**SYDNEY NORTH PLANNING PANEL COVER SHEET – PPSSNH-1
REPORT MEETING – 23 OCTOBER 2019**

Panel Reference	PPSSNH-1
DA Number	DA50/2019
LGA	Lane Cove Council
Proposed Development	Concept development application for a residential flat building
Street Address	20-22 Mindarie Street and 30 Pinaroo Place, Lane Cove
Applicant	NSW Land and Housing Corporation
Owner	NSW Land and Housing Corporation
Date of DA lodgement	13 May 2019
Number of submissions	Eleven (11)
Regionally Significant Development Criteria	CIV > \$5 million - Council party to an agreement CIV > \$5 million – Crown development
Capital Investment Value (CIV)	\$12,932,700.00
List of all relevant S4.15(1)(a) matters	<ul style="list-style-type: none"> • List all of the relevant environmental planning instruments: s4.15(1)(a)(i) <ul style="list-style-type: none"> - SEPP 55 – Remediation of Land; - SEPP 65 (Design Quality of Residential Apartment Development) and Apartment Design Guide (ADG); - Lane Cove Local Environmental Plan 2009; - Lane Cove Section 94 Contributions Plan 1996 (as amended). • List any proposed instrument that is or has been the subject of public consultation under the Act and that has been notified to the cons

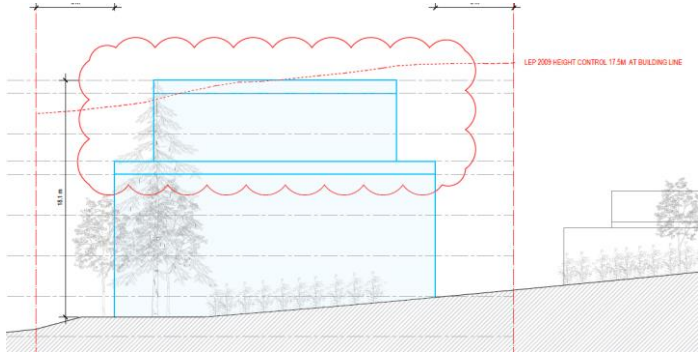
Concern	Comment
Building Height and Form	
The height should be limited to 17.5m and 5 storeys in accordance with the revised rezoning for the Mowbray Precinct.	The merits of the building height variation are addressed in the report, considered satisfactory and supported.
The 6 th storey should be 50% of the 5 th storey in accordance with the Mowbray Precinct DCP.	As outlined in the DCP table of compliance the upper storeys are considered capable of compliance with the DCP noting that balcony areas are excluded from the 50% requirement, but included in the proposed building envelope.
The scale of 2 Pinaroo Place is more appropriate which provides for better building separation to the adjoining residential properties.	The planning controls for 2 Pinaroo Place are not comparable to the subject site. The maximum building height of 2 Pinaroo Place is 14.5 metres under LCLEP 2009 and 4 storeys under the DCP, where the subject site is 17.5m and 5 storeys. In any event, the proposed building envelope provides
